REMARKS

ANNOTATED MARKED-UP DRAWINGS

FIG. 1
PRIOR ART

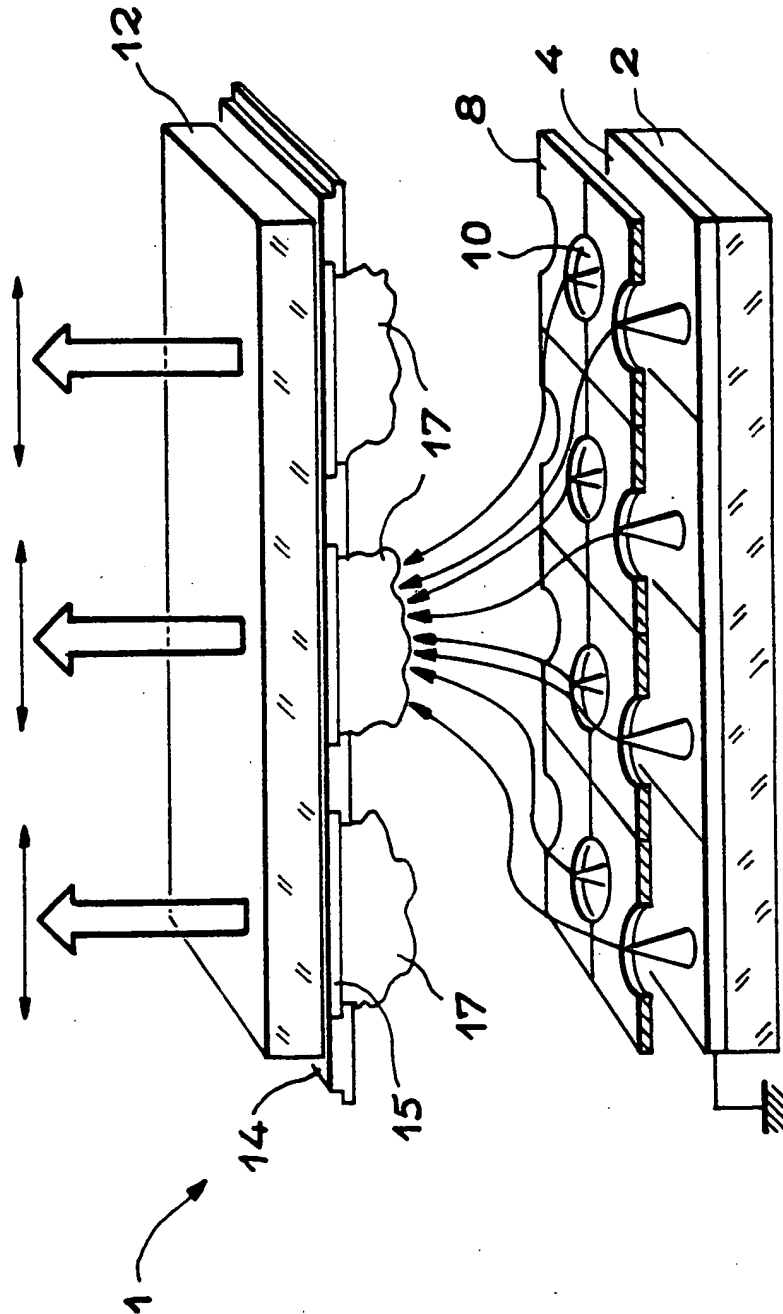
The drawings have been amended in response to the Examiner's request for the purpose of overcoming the Examiner's objection. Specifically, FIGS.1-5 stand objected to on the grounds that the legend "Prior Art" is missing. MPEP §608.02(g). FIGS. 1-5 have been amended to be designated with the legend "Prior Art." Applicant therefore requests that the objection to the Drawings be withdrawn.
